# 566 COLUMBUS AVE., BOSTON SOUTH END LANDMARK DISTRICT COMMISSION

5 MAY 2020

## South End Landmarks Design Review Comments | January 7, 2020

## APPENDIX

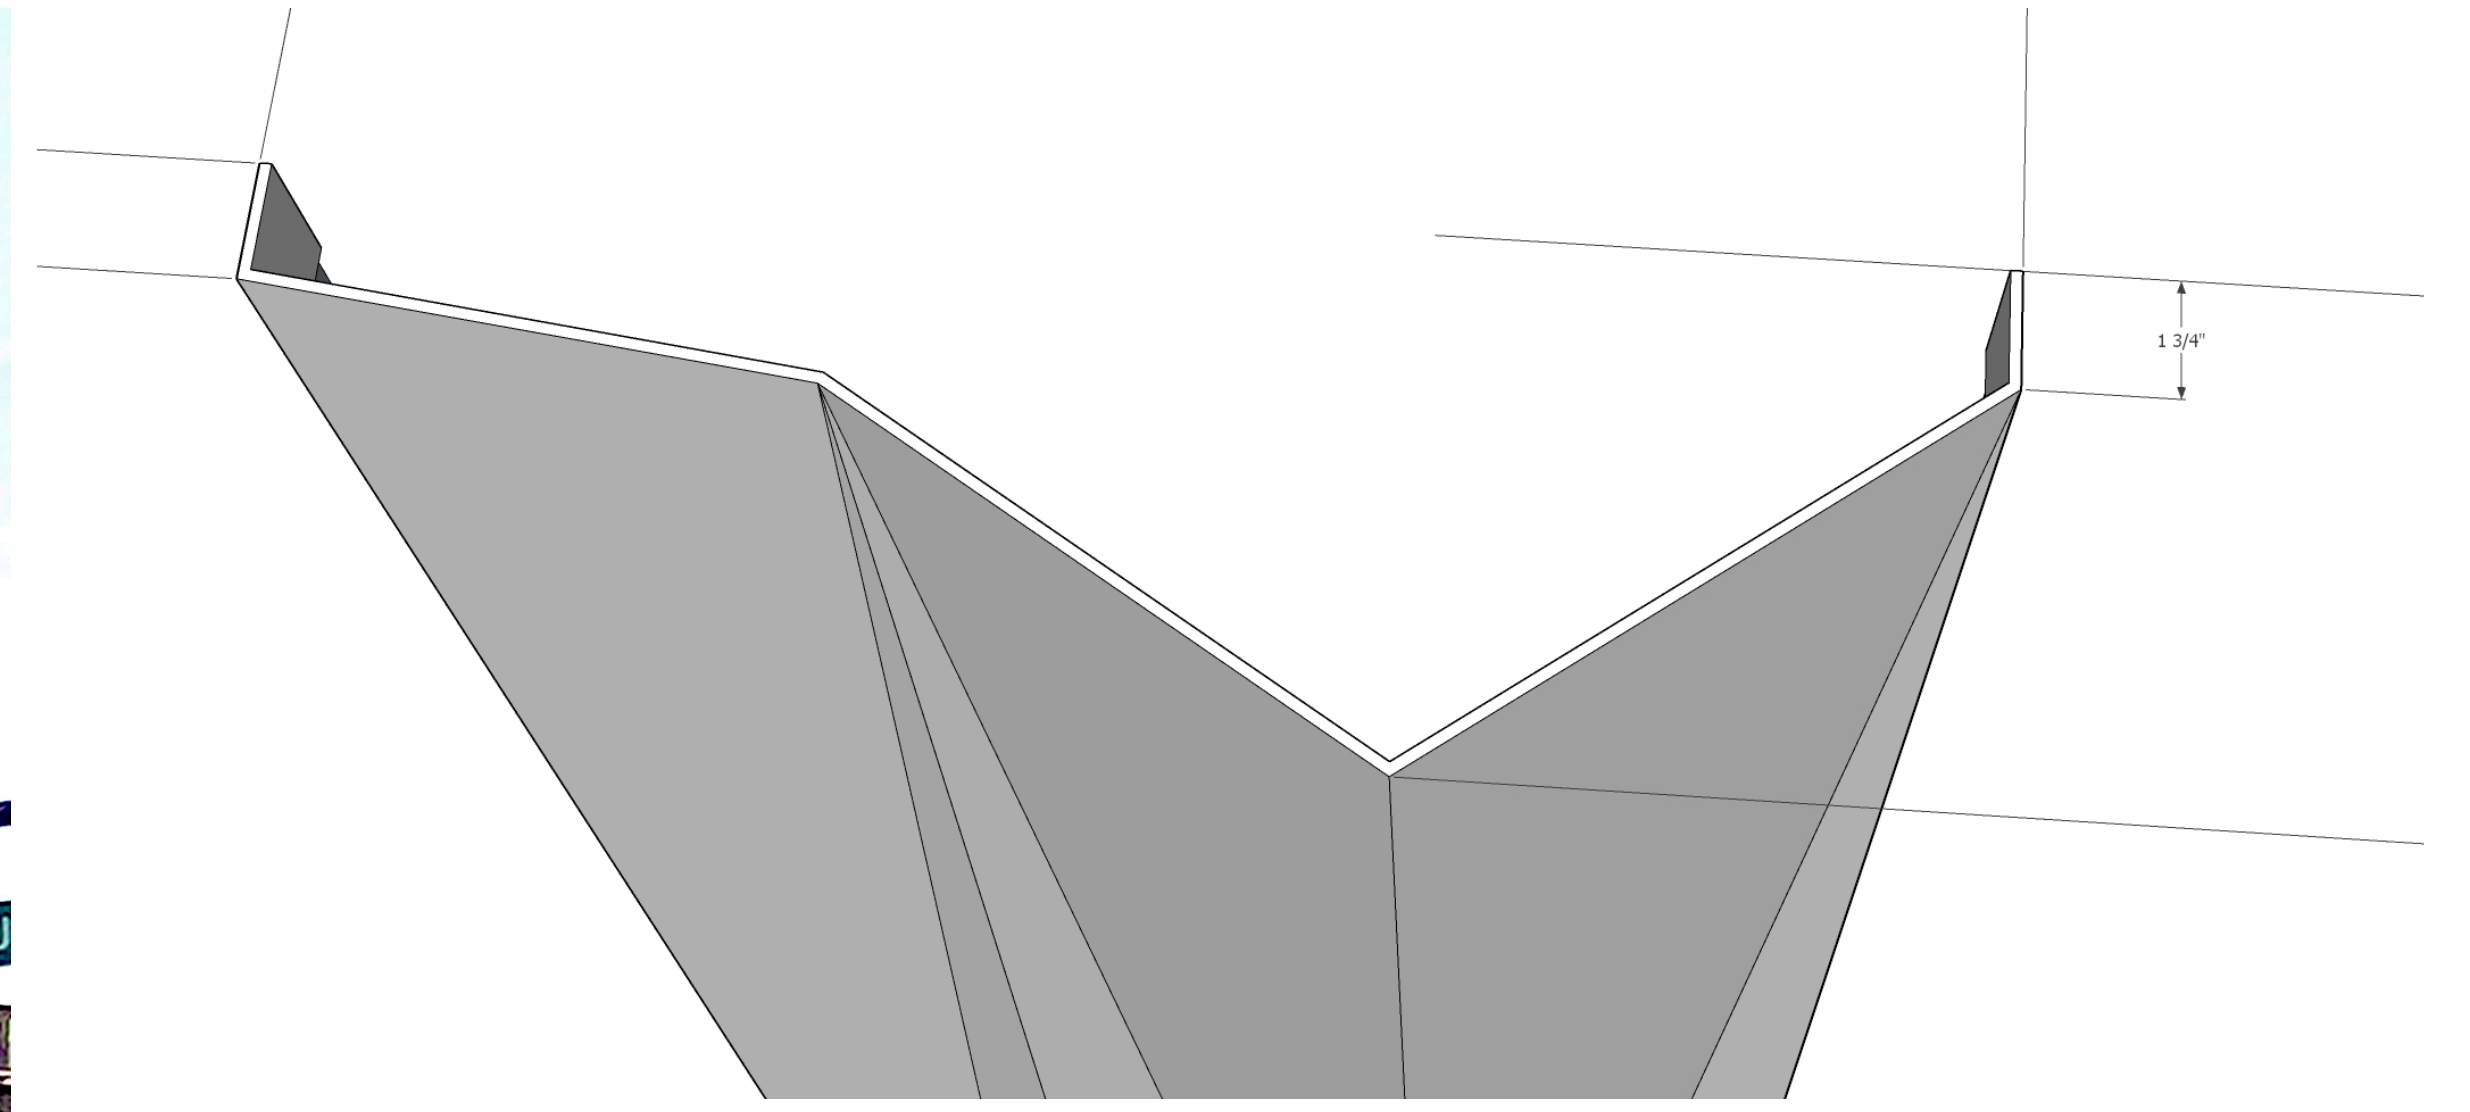
- *The “book-ending” treatment of the corner parcel is appropriate – historically buildings at the corners felt monumental*
- *Articulate window openings, take care in detailing*

- *Façade appears monolithic (flat), the façade should express modulation to break down the massing and read more as a group of residences*
- *Establish a hierarchical language between the vertical and horizontal bands*

- *Study the range of articulation around openings which typically appears more pronounced at entrances and parlor levels and becomes gradually less pronounced toward the upper floors*

- *Consider how this building acknowledges character defining elements consistent of the South End Landmark District; including but not limited to; steel pickets, iron work detailing, brick, metal, oriels, bays*

- *Examine the transitions with abutting buildings – acknowledge established datums of existing/adjacent buildings*
- *Garage door, detailing and visual aesthetic is important*

- *Metal corner composition, detailing and visual aesthetic is important*
- *Look to simplify and add clarity to the overarching moves*
- *Establishing the massing with two different materials is positive*

- WINDOW DETAILING
- RANGE OF ARTICULATION IN PUNCHED OPENINGS UP/DOWN THE FACADE
- COMPOSITIONAL MODULATION ALONG THE FACADE
- HIERARCHY: VERTICAL AND HORIZONTAL BANDS/BRICK DETAILING
- FACADE MATERIALITY AND COLOR
- TREATMENT OF ATTIC STORY / METAL DETAILING
- GARAGE DOOR
- STONE VENEER CLADDING AND GROUND LEVEL BASE CONDITIONS
- METAL CORNER ELEMENT, COMPOSITION AND DETAIL
- CHARACTER DEFINING ELEMENTS;
  - steel pickets/railings
  - brick masonry
  - metal
  - cornices
  - oriel windows
  - proportions & locations of openings
